February 10, 1987

SUBJECT: COMANCHE PEAK STEAM ELECTRIC STATION (CPSES)
DOCKET NOS. 50-445 AND 50-446
REQUEST FOR INFORMATION REGARDING INSPECTION REPORTS:
50-445/85-07, 50-446/85-05; 50-445/85-14, 50-446/85-11;
50-445/85-16, 50-446/85-13; 50-445/86-06, 50-446/86-04

SUPPLEMENTAL REQUEST FOR INFORMATION REGARDING
INSPECTION REPORTS
50-445/85-07, 50-446/85-05; 50-445/85-14, 50-446/85-11;
50-445/85-16, 50-446/85-13; 50-445/86-06, 50-446/86-04

CONCRETE TESTING DATA MANAGEMENT

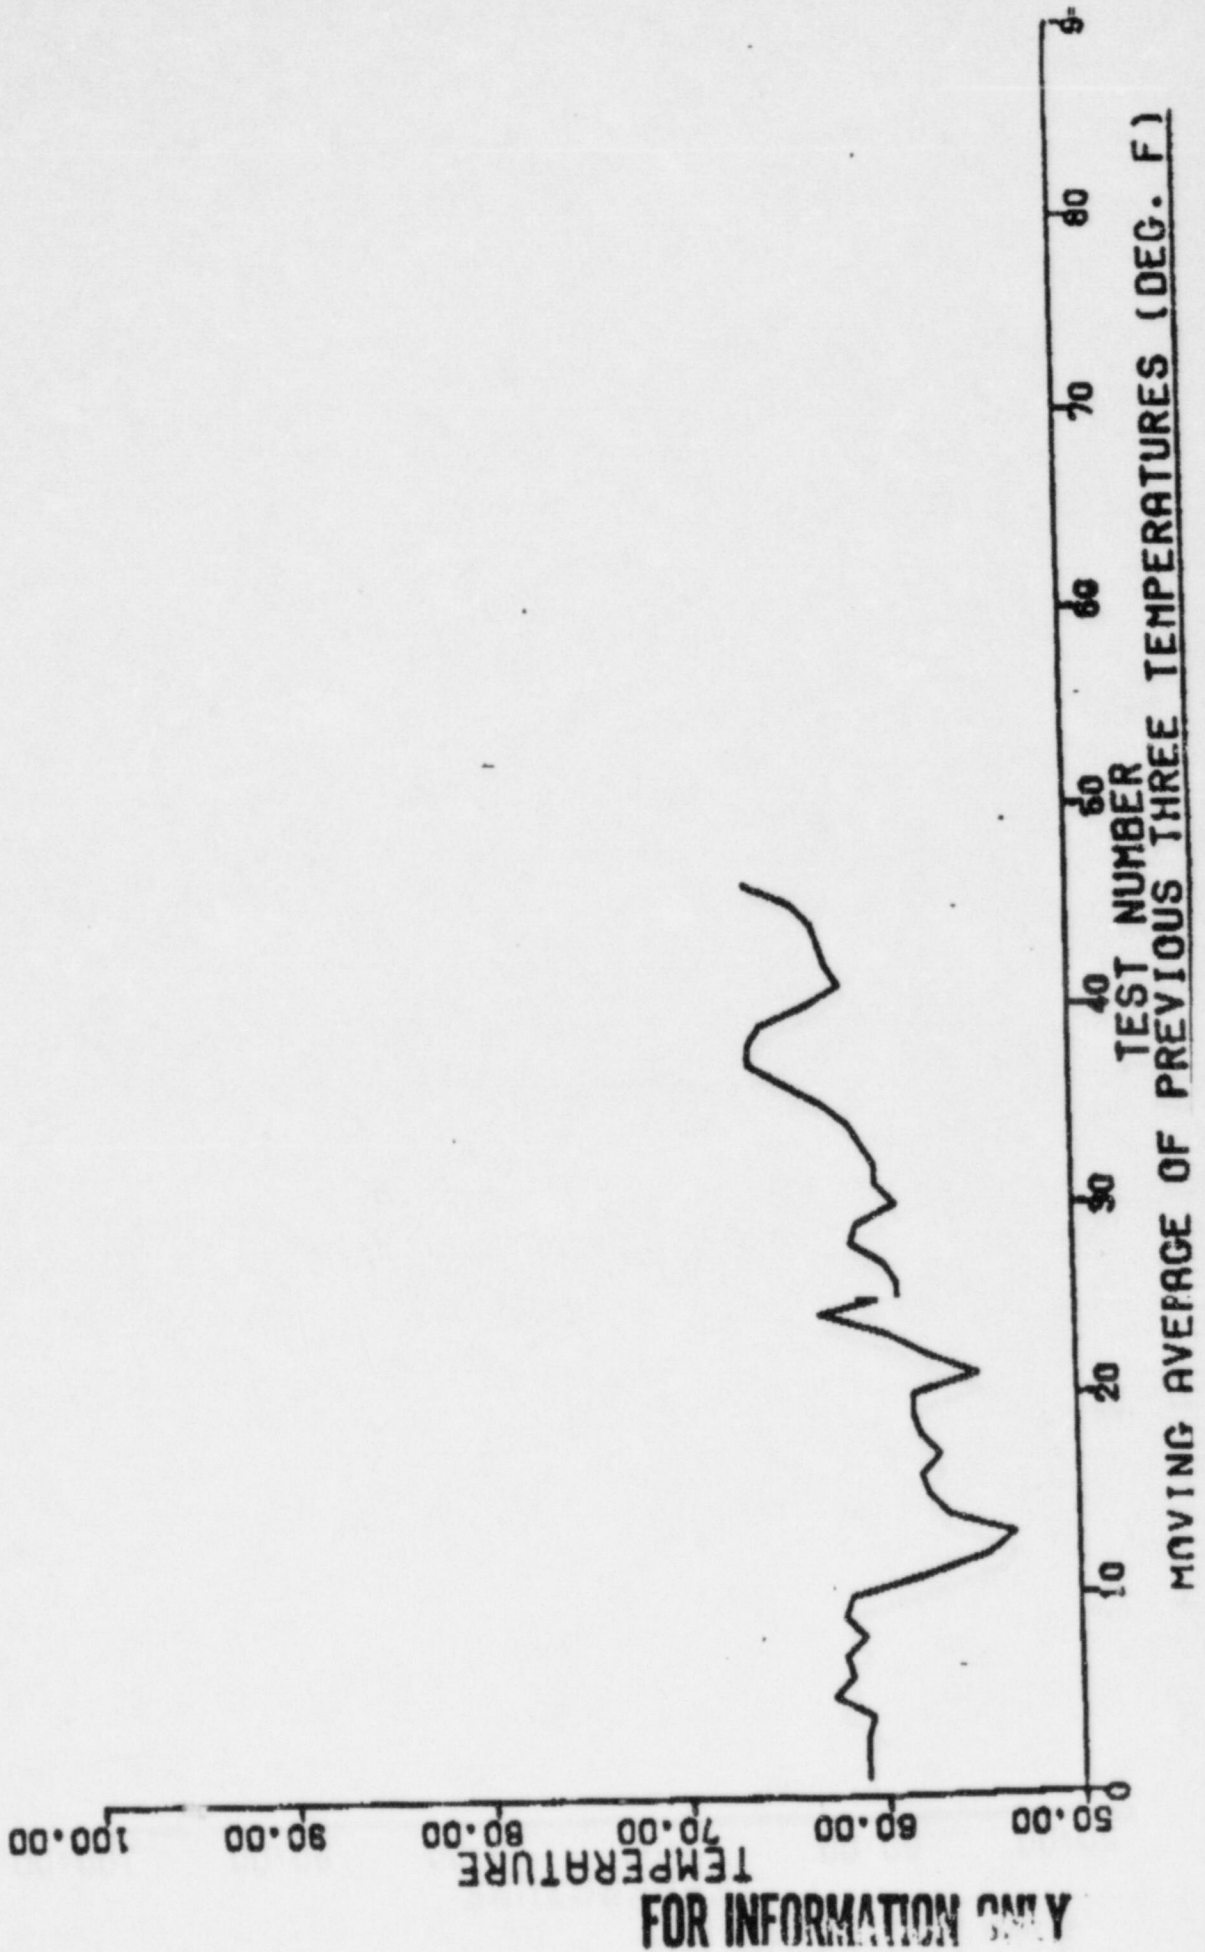
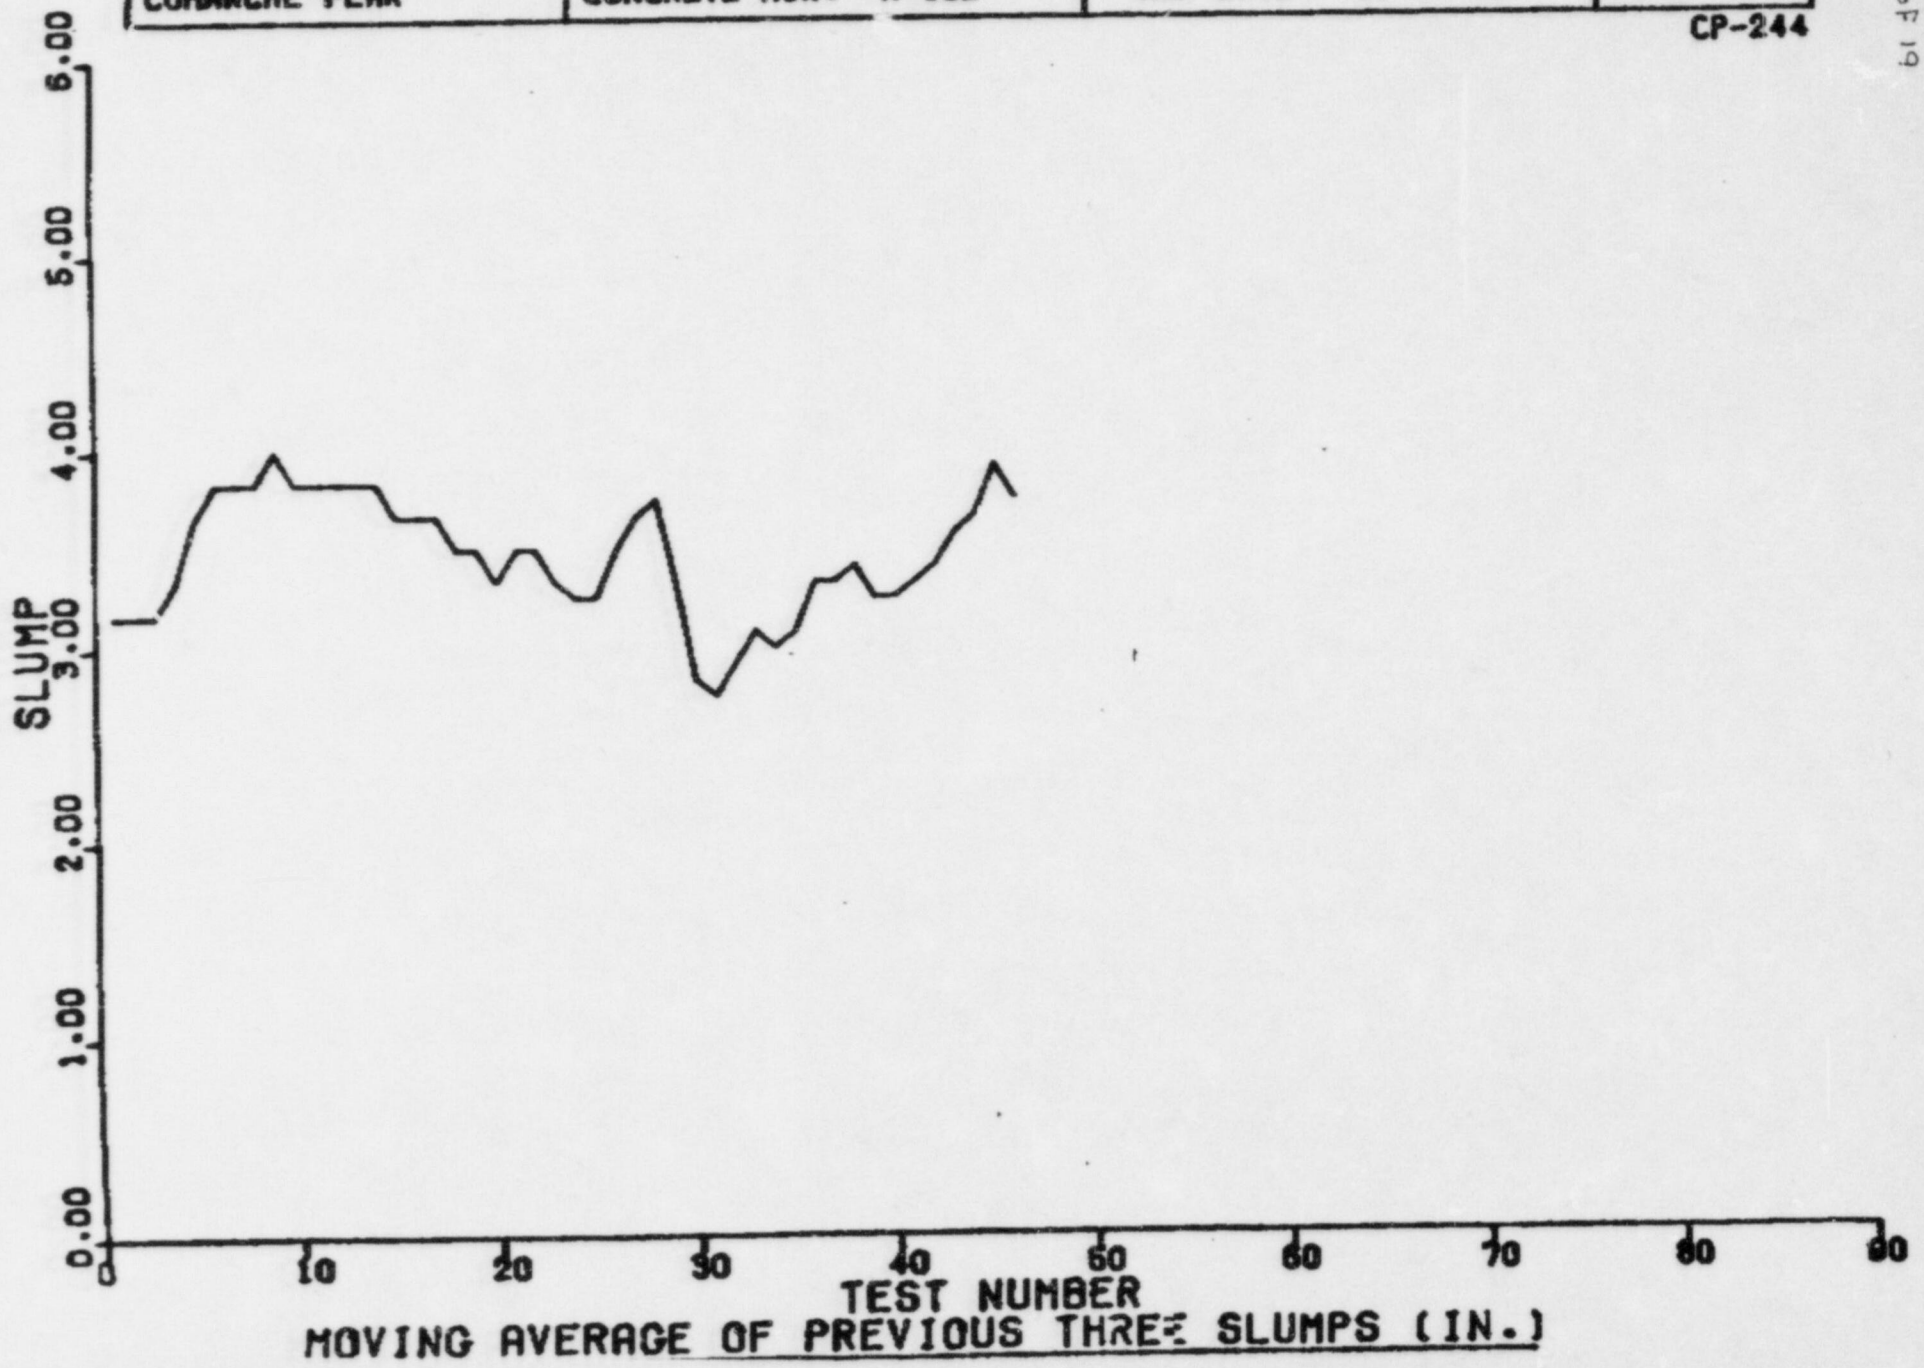
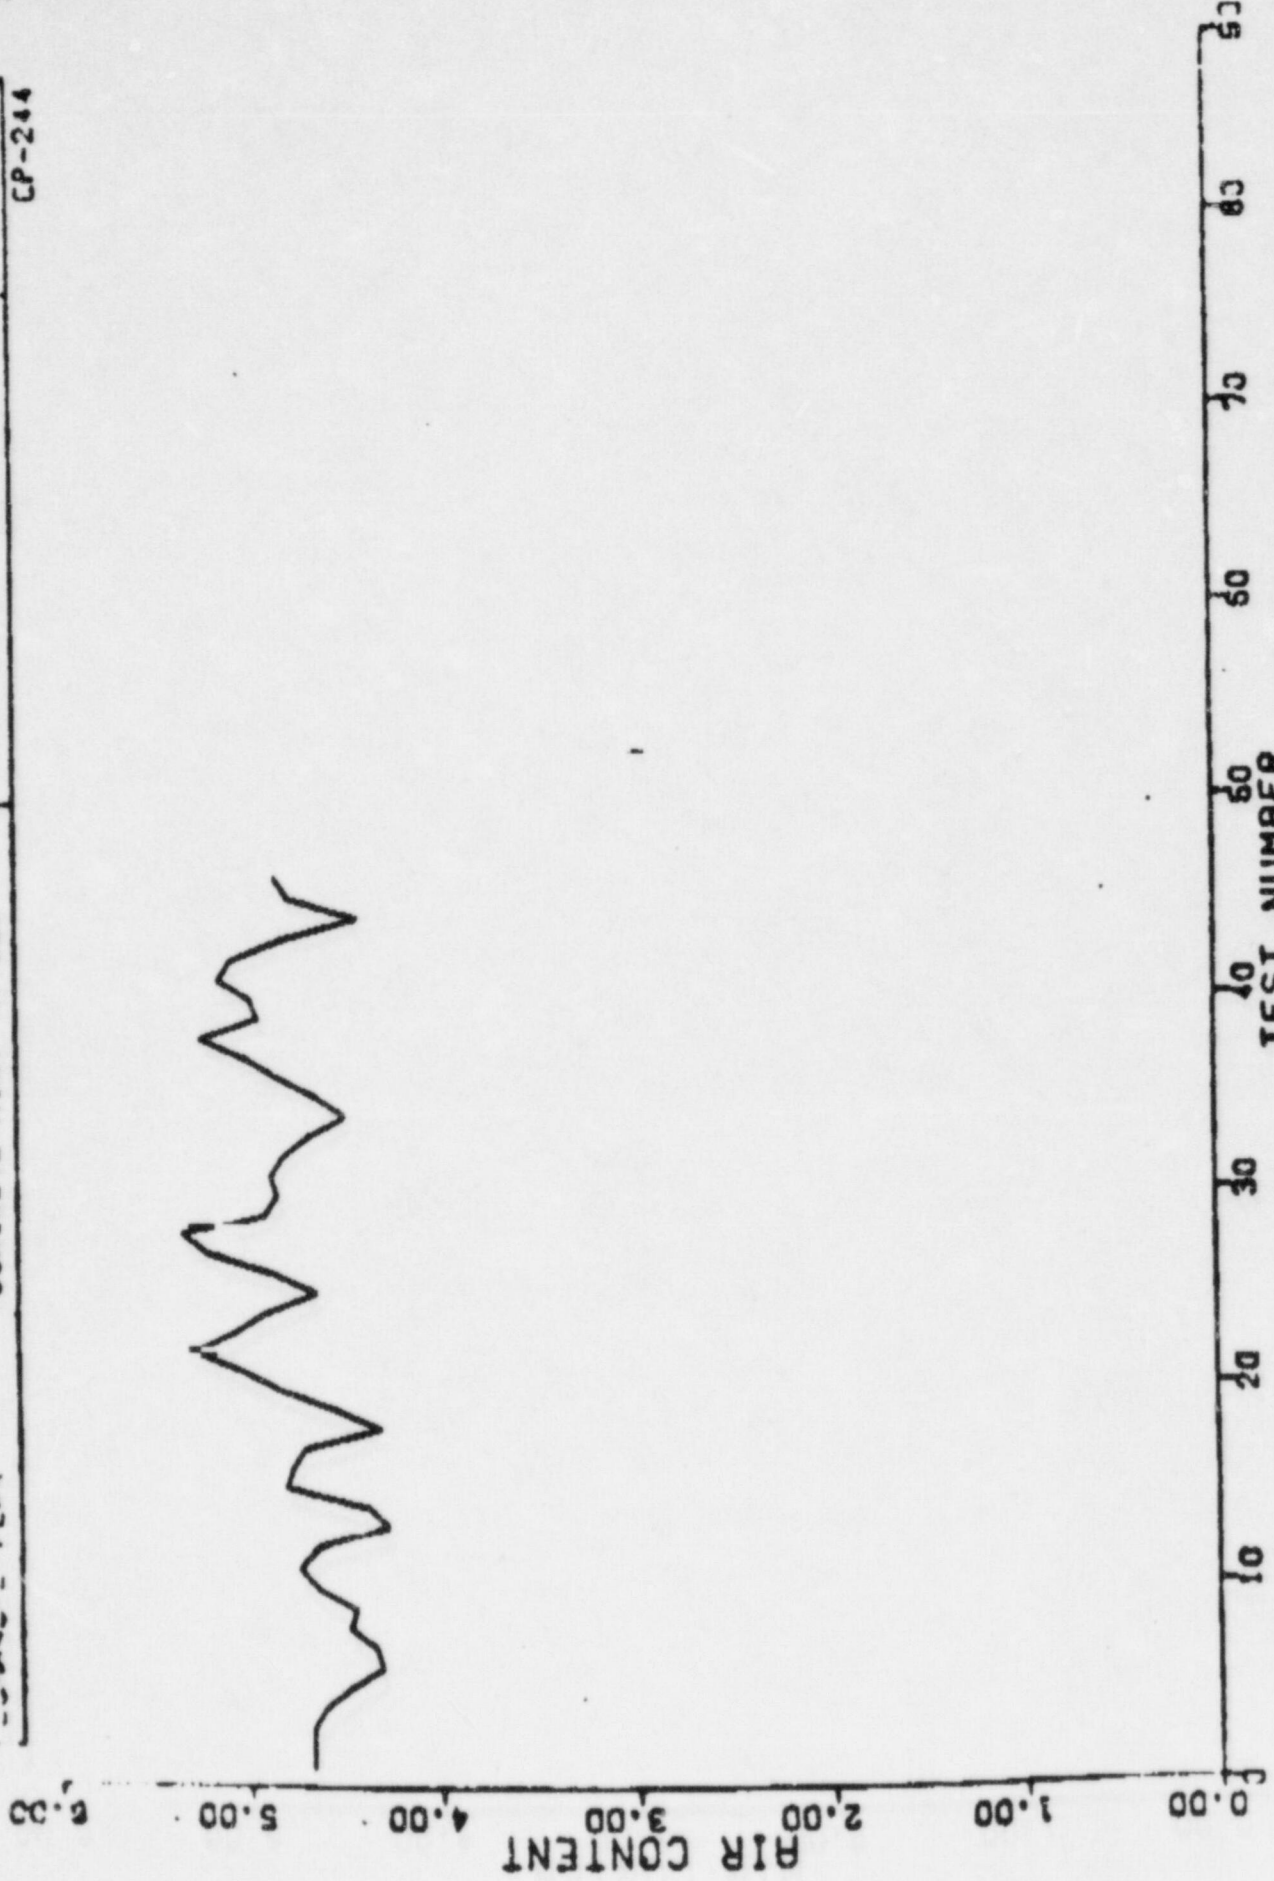
4. With reference to inspection report 50-445/85-07, 500-446/85-05, and NOV 445/8507-04, 446/8505-02, although no records exist that concrete mixing blades had been inspected quarterly since trucks were placed in service in 1977, it is our understanding that there are consistent concrete strength and uniformity tests.
 - a. Does TU Electric have a concrete strength statistical distribution for this period?
 - b. Provide three (3) results reports spaced over this period (i.e., 1977, 1980 and 1984).

Enclosure 1 is a statistical evaluation of a series of concrete tests run during 1978. This is one of several statistical evaluations run during the 1973 to 1979 time frame.
